February 2025 Draft Lithium Valley Specific Plan

Public Review Comments

Section 1: Federal, State and Local Agencies

4. **Figure 2-2, Lithium Valley Vision, Pg 32**

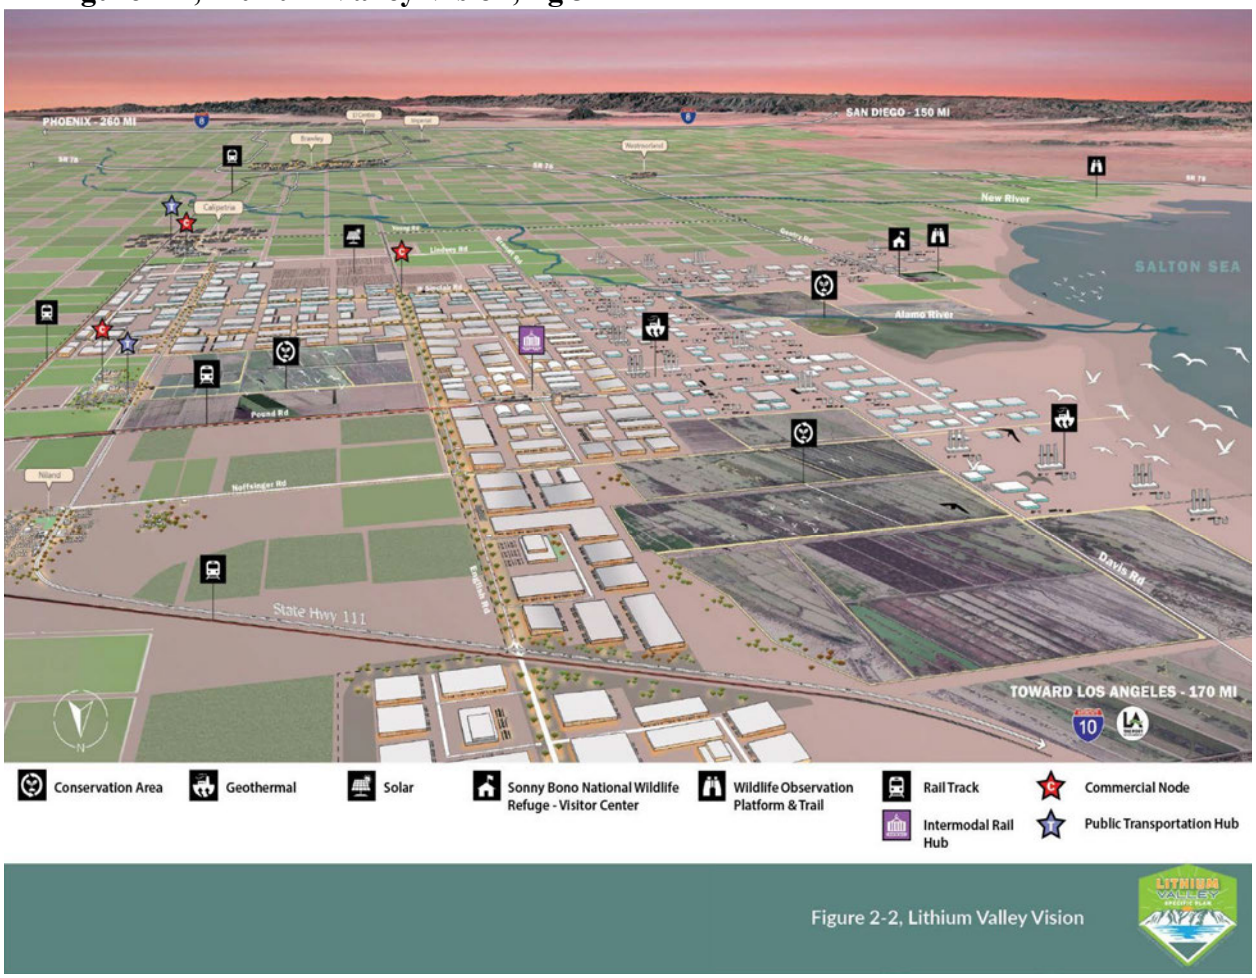
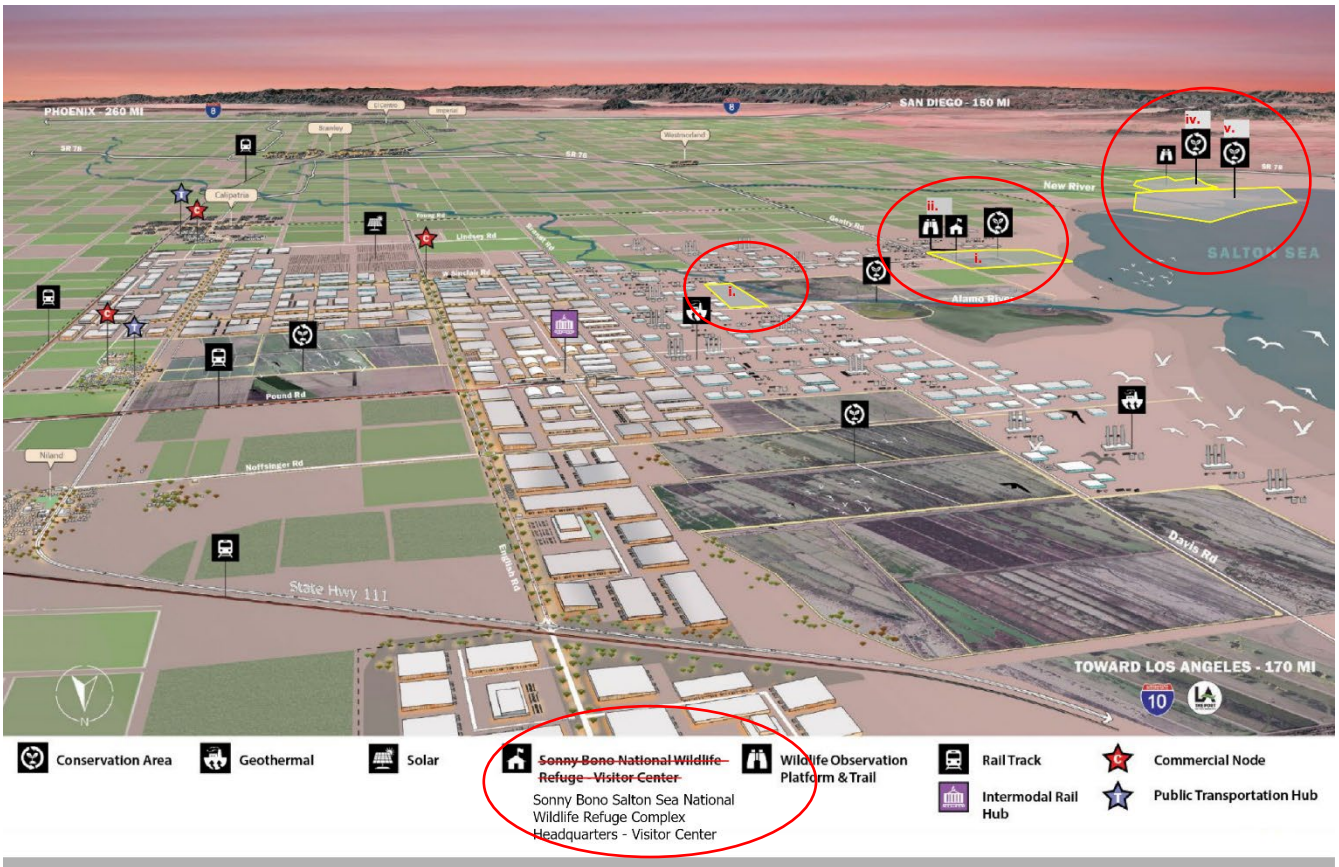
a. In its current iteration, the Figure is missing or incorrectly labels the following entities:
    i. The Refuge Unit 2 Headquarters sub-unit is not correctly labeled as a conservation area, nor is the area footprint for the Hazard Subunit reflective of the full extent of the conservation area. The Hazard Subunit is managed as part of the Refuge by the USFWS, but it is owned fee-title by the CDFW. Please refer to the corrections in **Figure 2.**
    ii. The Refuge Unit 2 observation platform and trail label are misplaced. Please refer to the corrections in **Figure 2.**
    iii. The Sonny Bono Salton Sea National Wildlife Refuge Visitor Center, which is also a part of the headquarters, is not properly labeled. The Refuge's proper name is the Sonny Bono Salton Sea National Wildlife Refuge. The correct label should read Sonny Bono Salton Sea National Wildlife Refuge Complex Headquarters – Visitor Center

iv. While the Figure does show the correct location of the Refuge Unit 1 observation tower, it does not correctly outline or label the whole unit as a conservation area. Please refer to the corrections in **Figure 2.**

v. The Figure is missing the State of California's Salton Sea Management Program Species Conservation Habitat (SCH) Project as a conservation area. Please refer to the corrections in **Figure 2.**

Figure 2. Lithium Valley Vision Map with all requested corrections. Corrections are circled in red and marked with their corresponding comment when needed.

5. **Figure 2-3, Lithium Valley Concept Map, Pg 33**

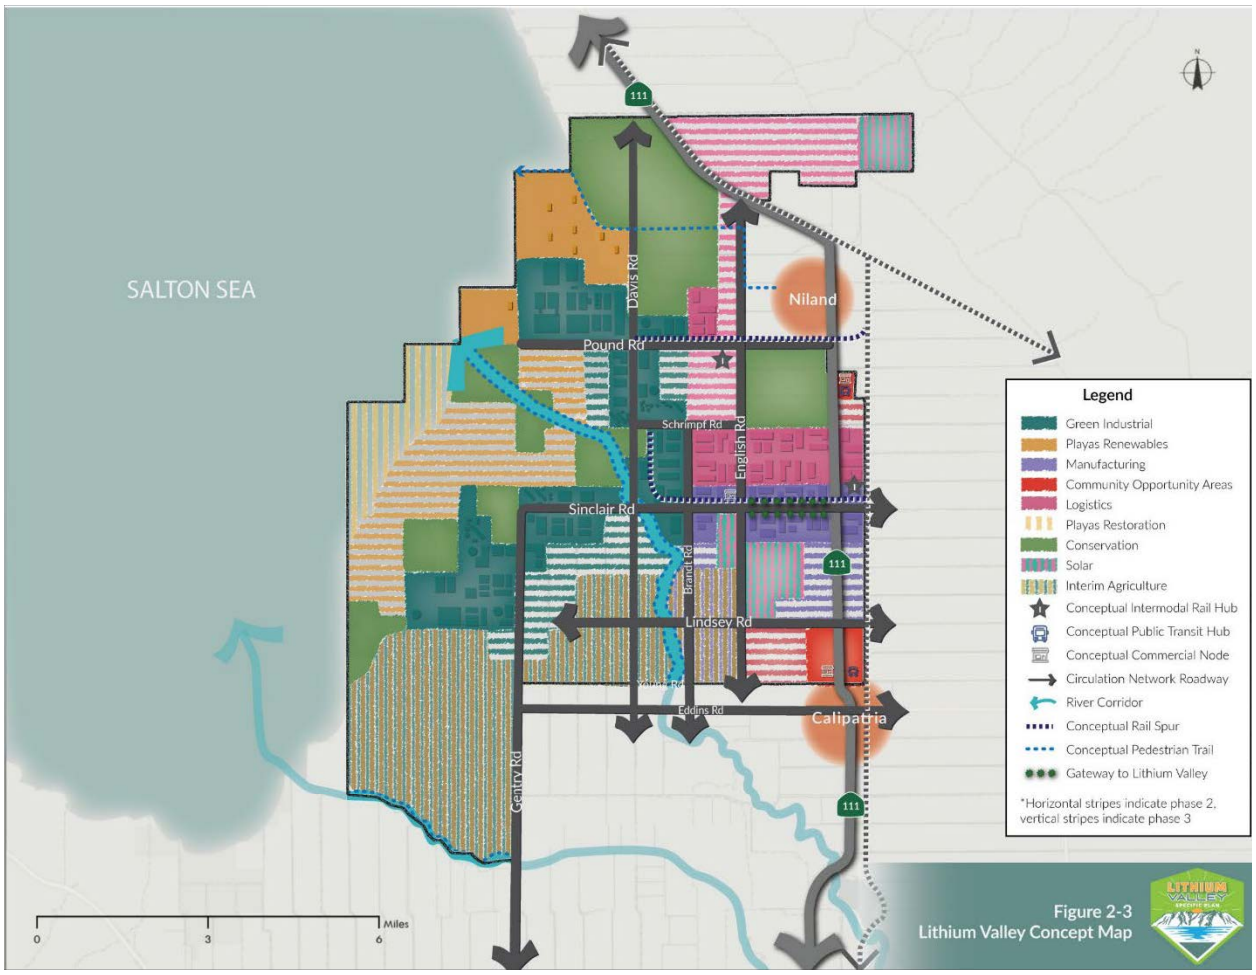
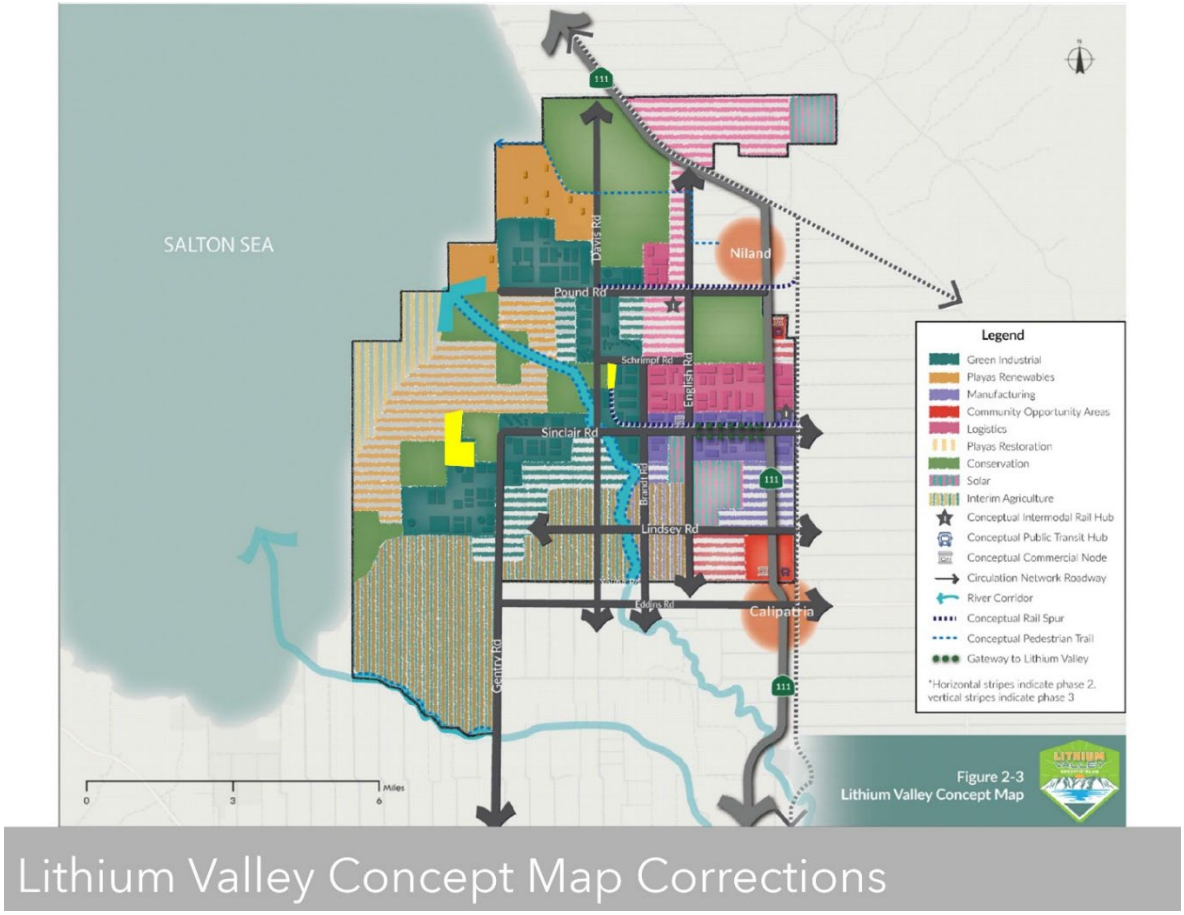
a. The Figure does not correctly represent the Refuge management units within its conservation designation. Please refer to the corrections in **Figure 3** below and **Figure 1** for the overall Refuge boundary.

b. The figure and overall plan fail to define what constitutes a conservation area/land designation. In its current configuration, this figure and the plan label both federally and state-protected lands as wildlife conservation areas and define them the same as potential future mitigation sites. This can be misleading, as both federally and state-protected lands cannot be used as mitigation sites (2008 Compensatory Mitigation Rule, 73 FR 19670, April 10, 2008).

Figure 3. Lithium Valley Concept Map with requested correction in yellow polygons

6. **Figure 3-1, Land Use Map, Pg 36**

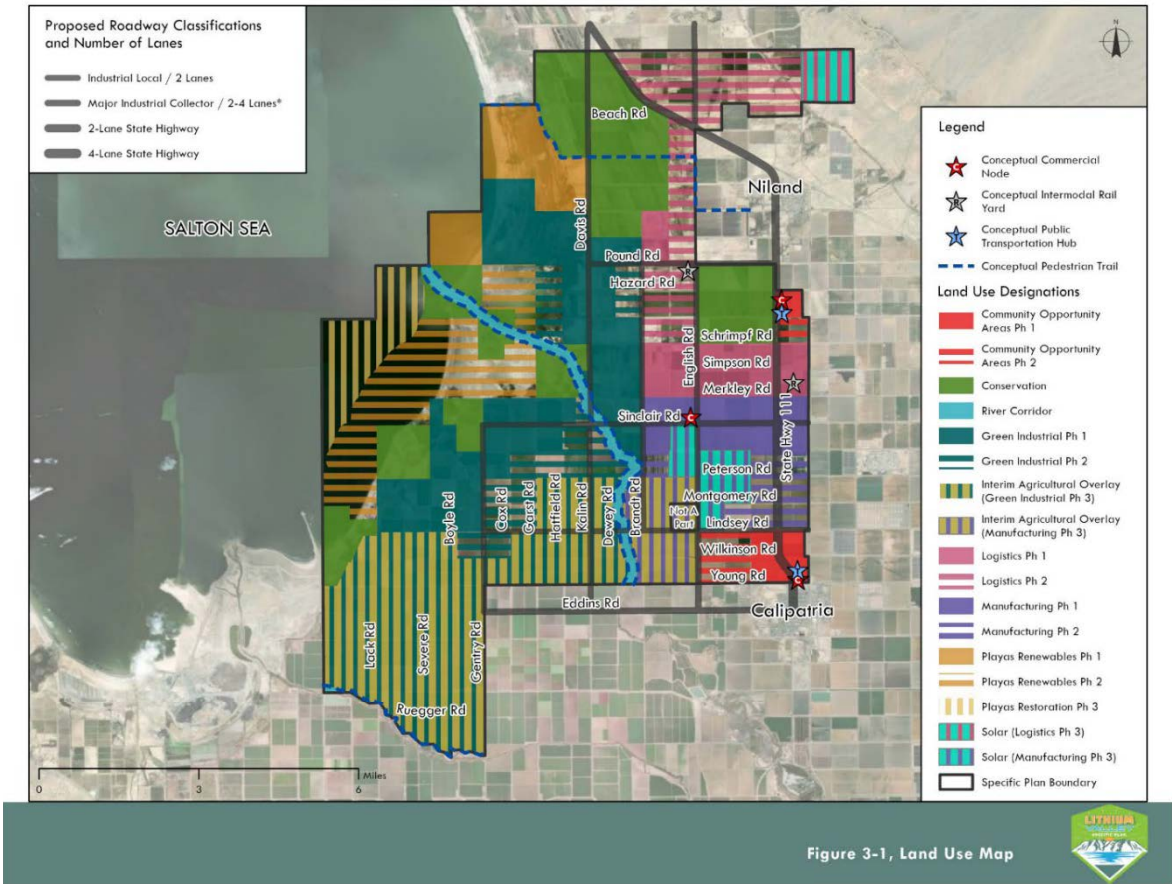
a. The Figure does not correctly represent the Refuge boundary within its conservation designation. Please refer to the corrections in **Figure 3** and **Figure 1** for the most accurate depiction of the Refuge boundary and management units.
   b. Please refer to comment 5.b.

8. **Figure 3-3, Interim Agriculture, Pg 44**

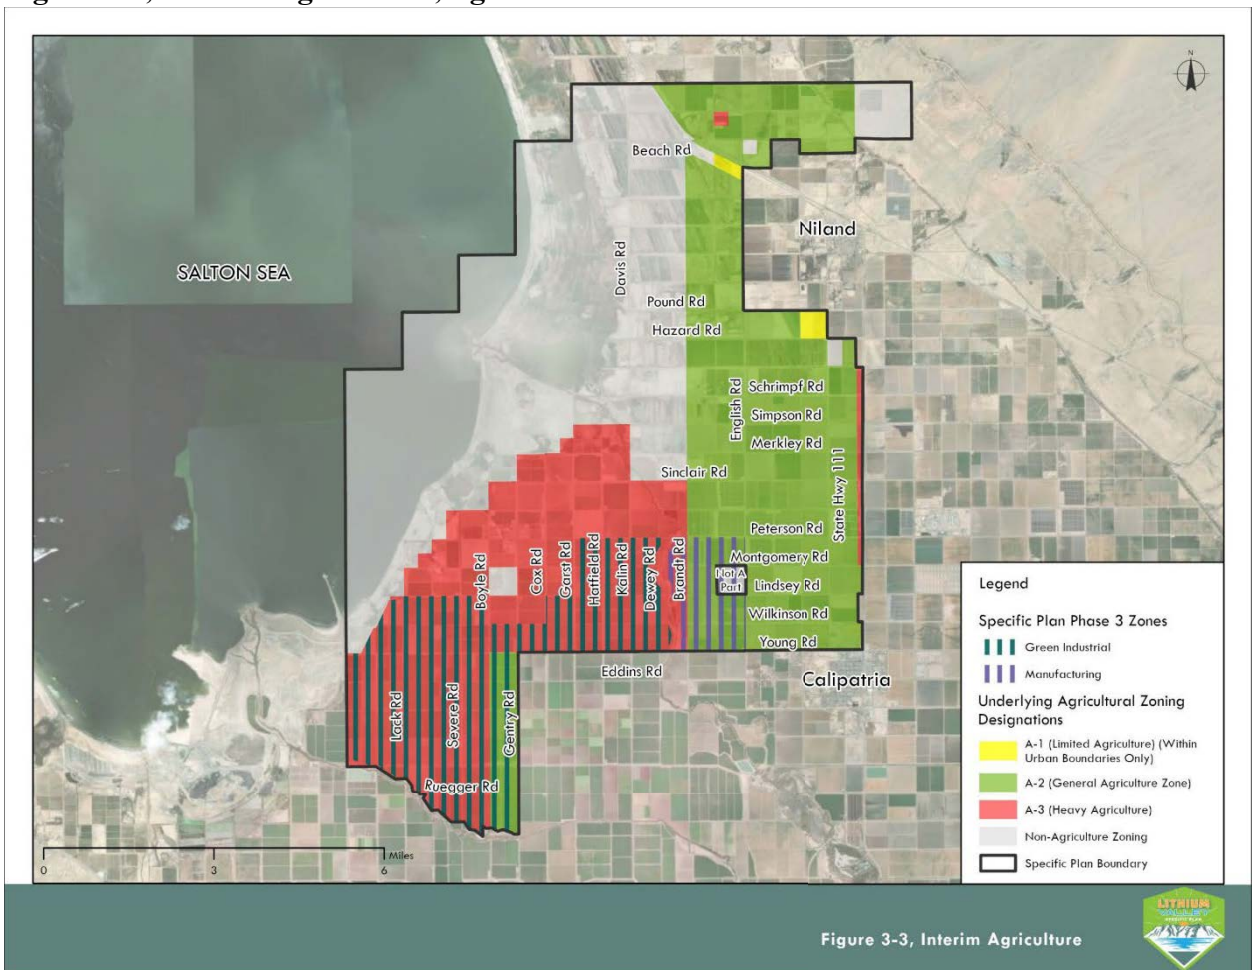
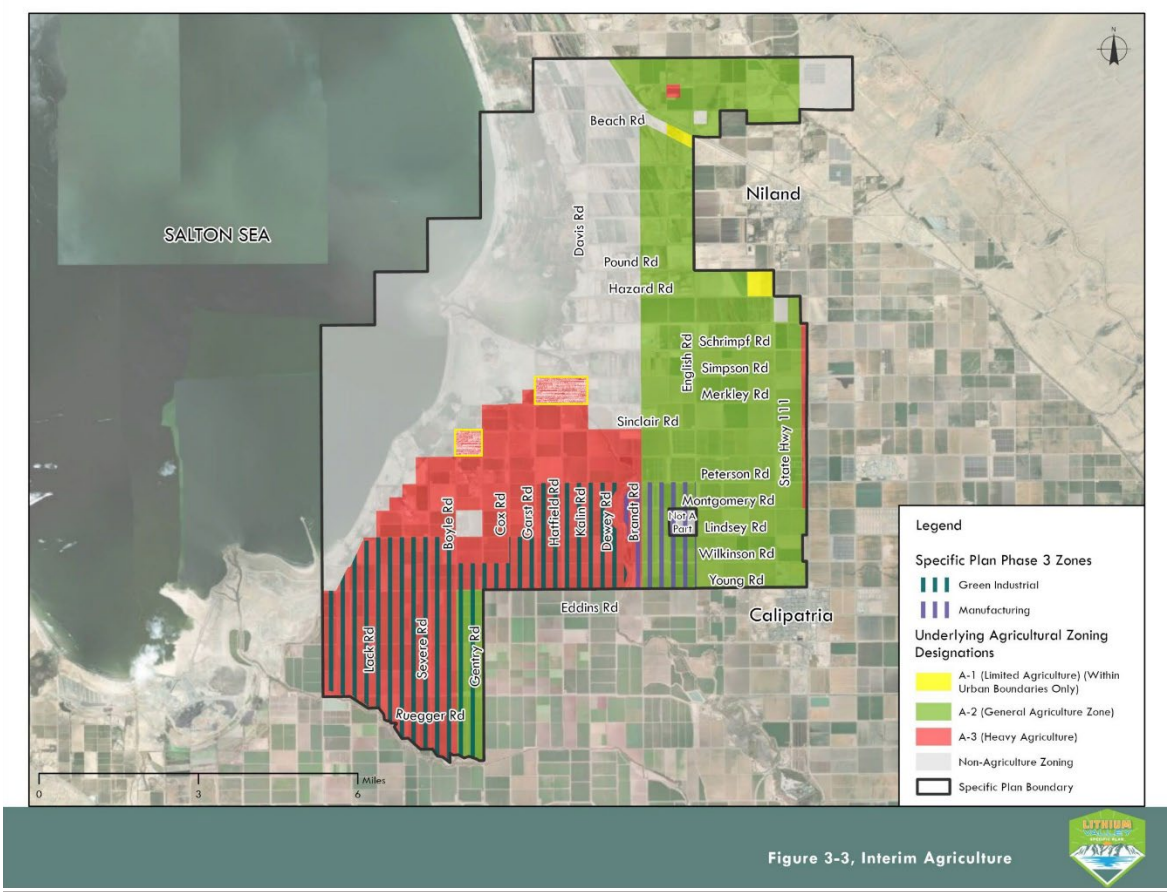
a. The figure does not correctly represent the Refuge boundary and mislabels the south end of the Hazard Subunit, and both irrigated upland fields, 419 and 420, as A-3 (Heavy Agriculture).
    i. All three of the mentioned locations, Hazard Subunit, Field 419, and Field 420, are federally protected lands within the Refuge and should be referred to as such. Please refer to the corrections in **Figure 4** and **Figure 5** for the locations of the above-mentioned fields and Hazard Subunit.

Figure 4. Interim Agriculture Map with requested correction in yellow polygons showing the actively managed Refuge Units incorrectly labeled as A-3 heavy agriculture.

9. **Figure 3-4, Phasing Map, Pg 51**

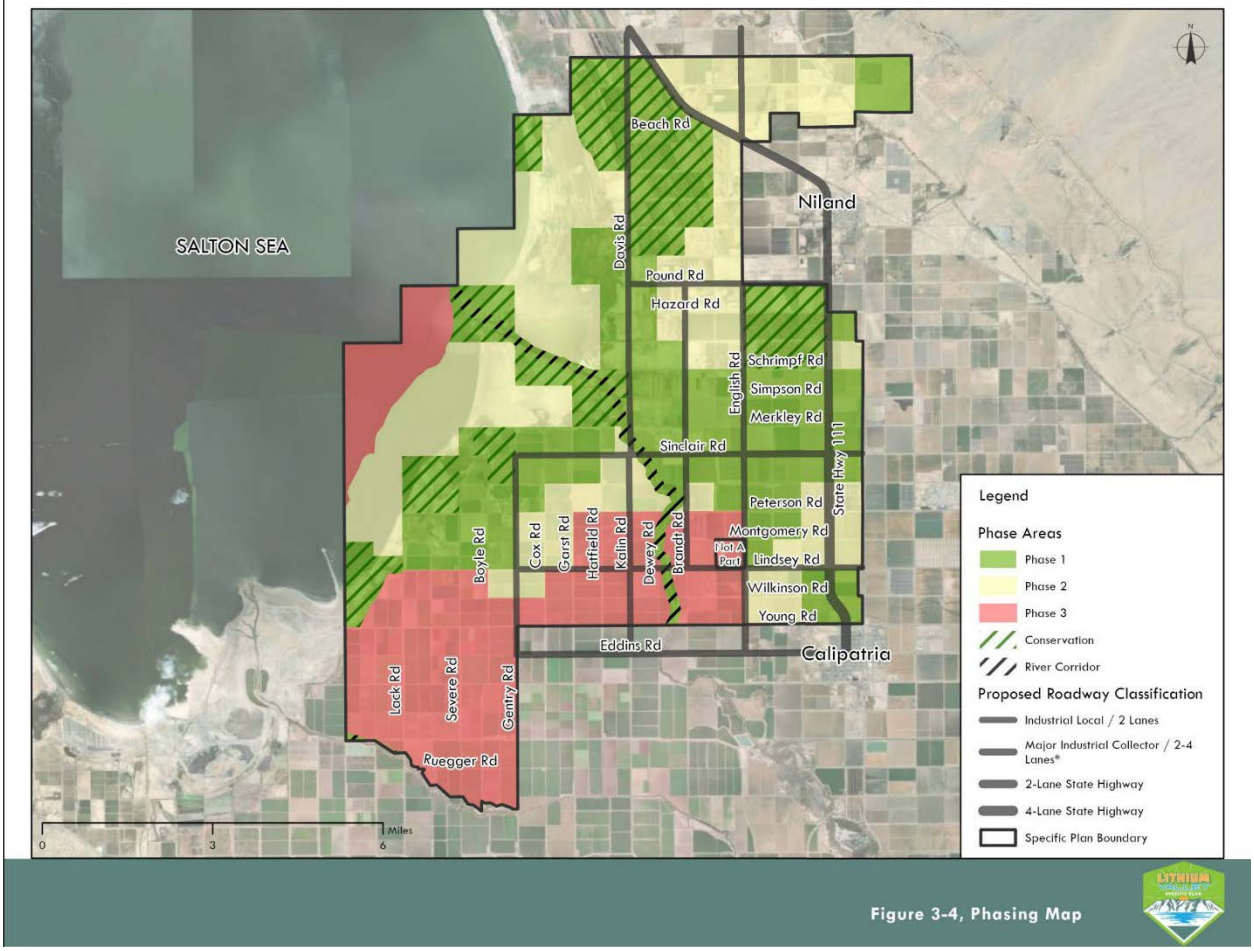
a. The Figure does not correctly represent the Refuge boundary within its conservation designation. Please refer to **Figure 1** and **Figure 5** for the correct Refuge boundary. Additionally, please refer to **Figure 3** for the correct conservation area boundary.

10. **Figure 5-1, Roadway Network, Pg 93**

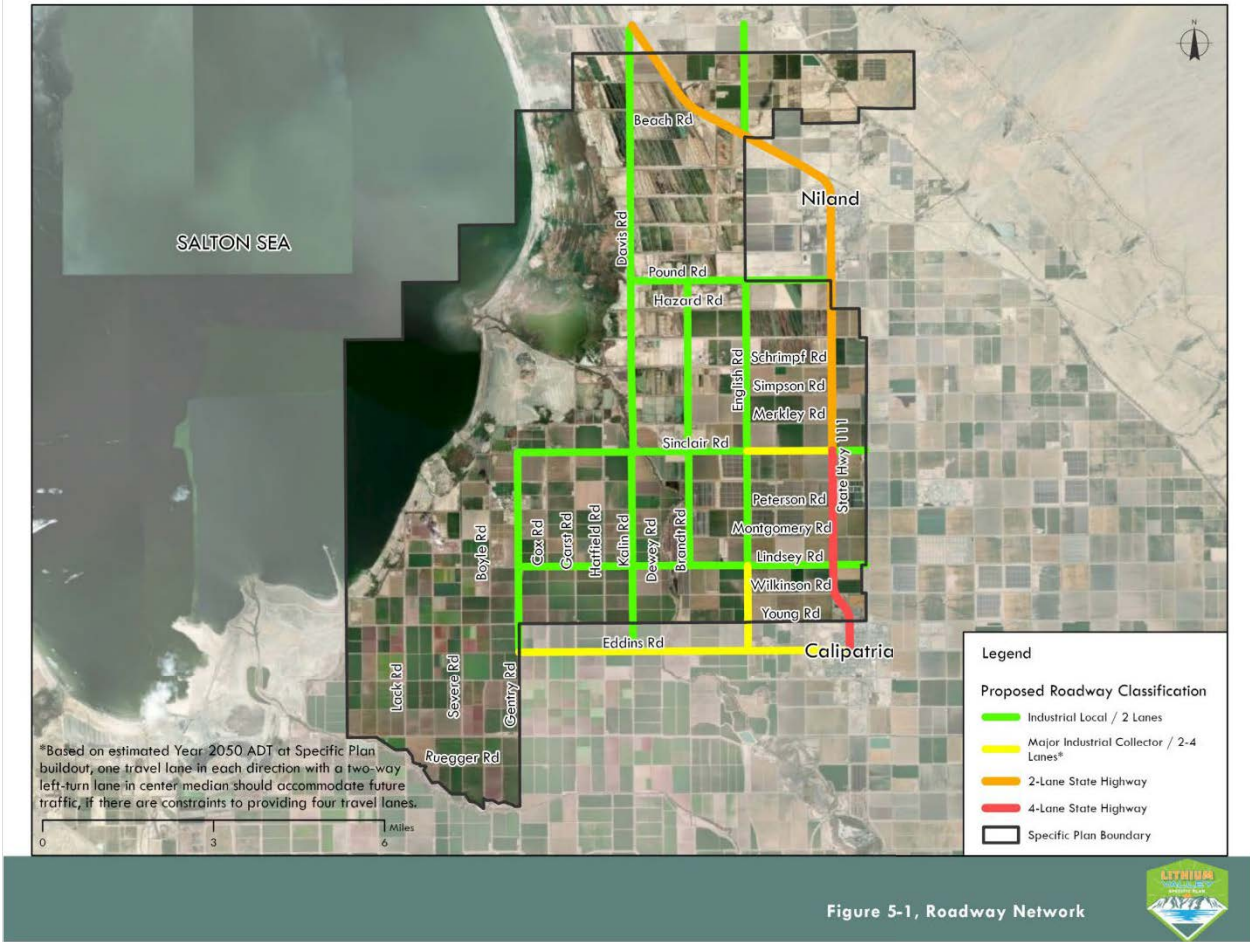
a. As the Figure is currently displayed, an Industrial Local / 2 Lanes proposed roadway, Davis Road, will cut through both the Hazard Subunit and the entirety of Wister. The proposed location of Davis Road would divide the Hazard Subunit in half and would intersect right through both the under-construction endangered species habitat referred to as the Willows site, and H11/12 seasonal shallow water wetland, **Figure 5,** an actively used public hunt site H11A through H13, **Figure 6**. Additionally, Wister is a highly used state-protected and operated hunting area and would have similar, if not greater, impacts if an industrial 2-lane road were to be installed within its boundary **Figure 7**.
